**2016 ANNUAL GROUNDWATER
MONITORING REPORT**

**FORMER RADIO RELAY STATION
PORT HEIDEN, ALASKA**

**Final
February 2019**

FIGURE NUMBER:
4-3

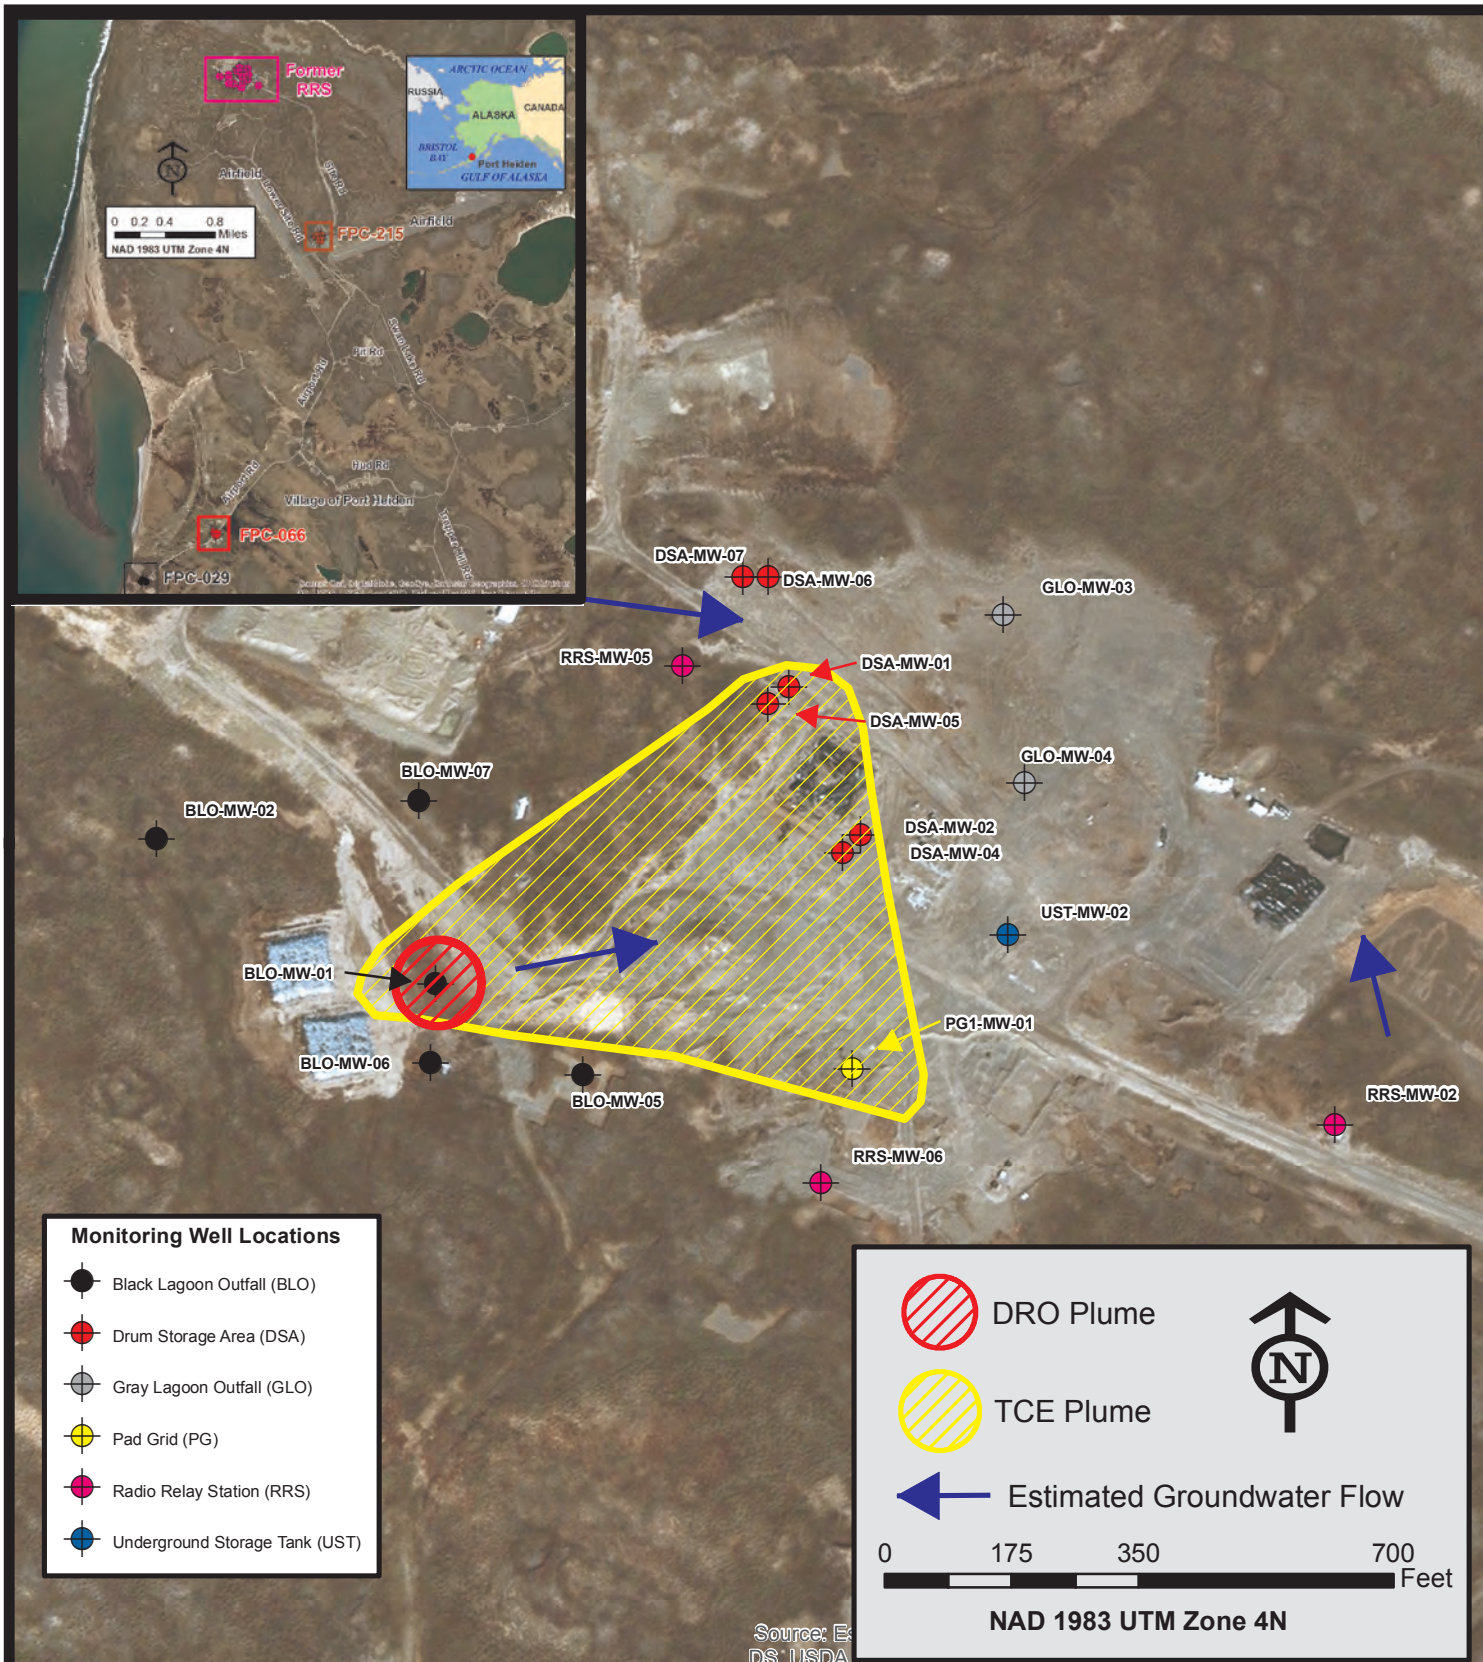
11.	Fig 4-3	In the Monitoring Well Type box Suggest adding (BLO) after the Black Lagoon Outfall label, please apply this to each well type. Also spell out what PG stands for if known.	A	Acronyms added to the explanation. PG stands for Pad Grid. as part of the RIFS conducted in 2004 and reported in April 2006 a grid was established between Antennas 1 and 2 and designated as Pad Grid 1 and the well was placed in that area.

11.	Figure 4-3	Table 4-3 does not show an exceedance for DSA-MW-05 but this well is inside the boundary of the TCE plume. Is this correct?	--	The plume maps are estimated extents of groundwater contamination and APCS considers the extent of the plume may include contaminated groundwater at a greater or lesser	Figure 4-3 does not show a dashed plume extent for DSA-MW-05.
